REQUEST FOR DECISION

OCP and Zoning Amendment Application
Tyax Real Estate – Tyax Lodge

Meeting date: January 13, 2016

File No. 3360.20.89

Floor Plans 1:100 scale

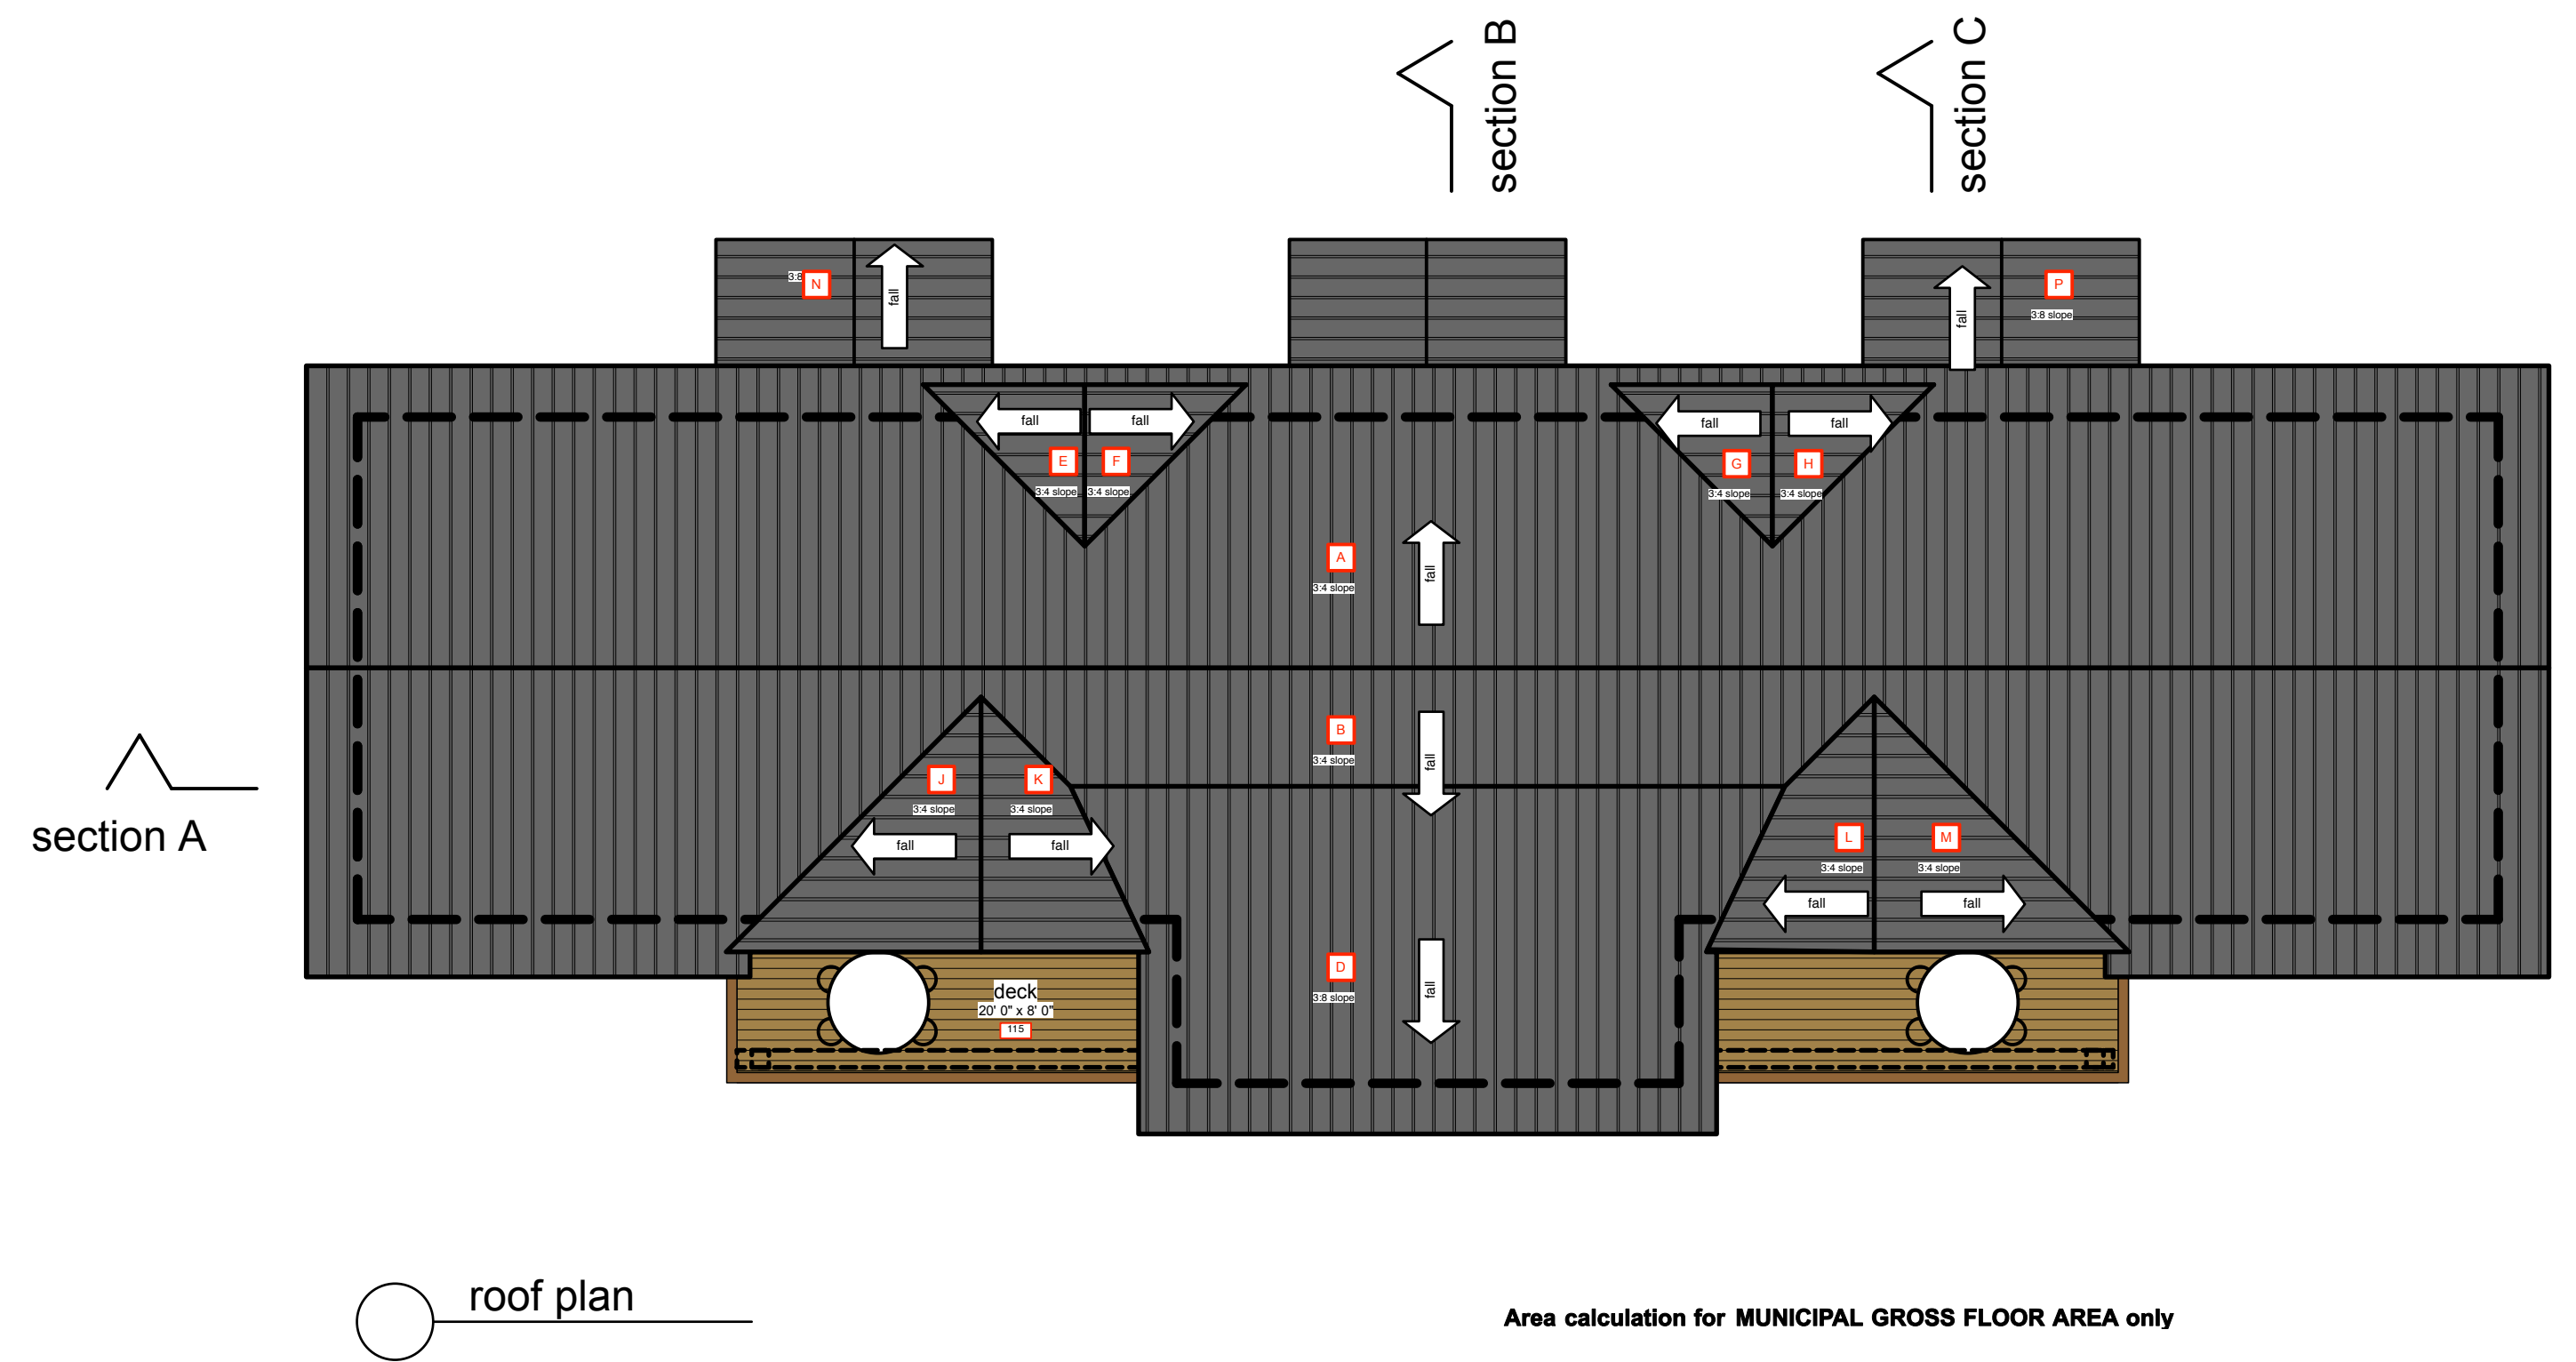
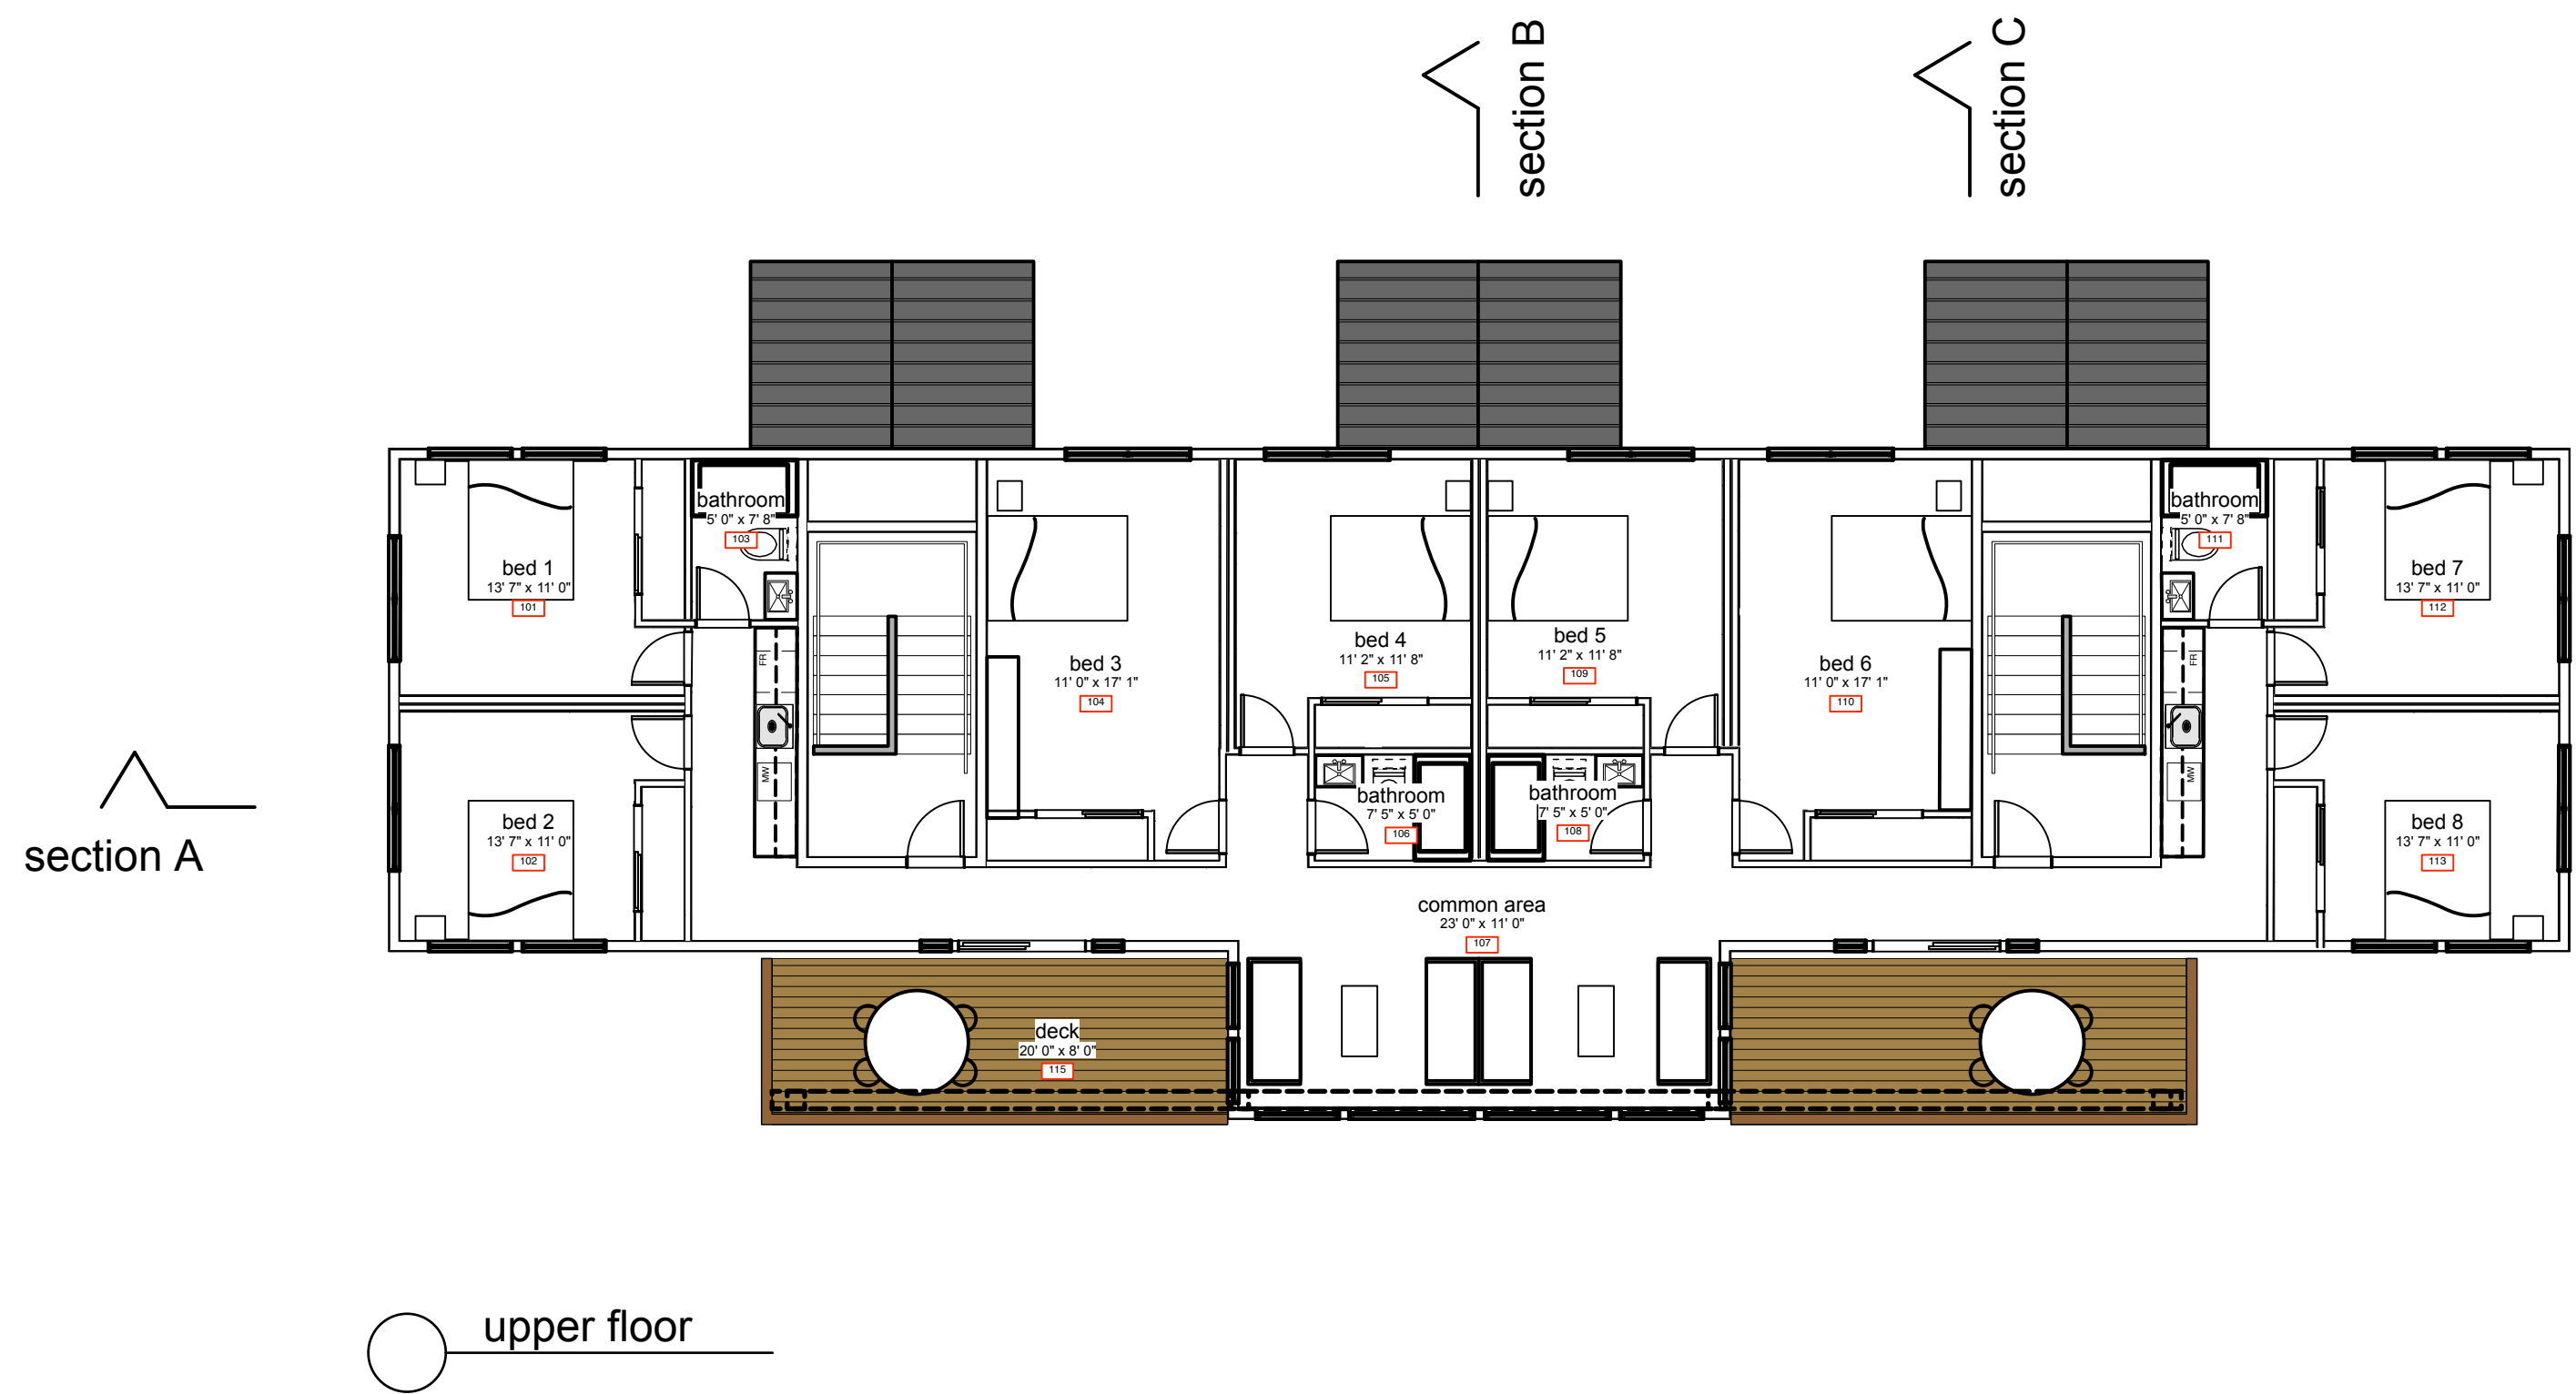
c/ Clarify floor area calculations :

The revised application provides more precise gross floor area of the proposed operations building along with it's main floor footprint.
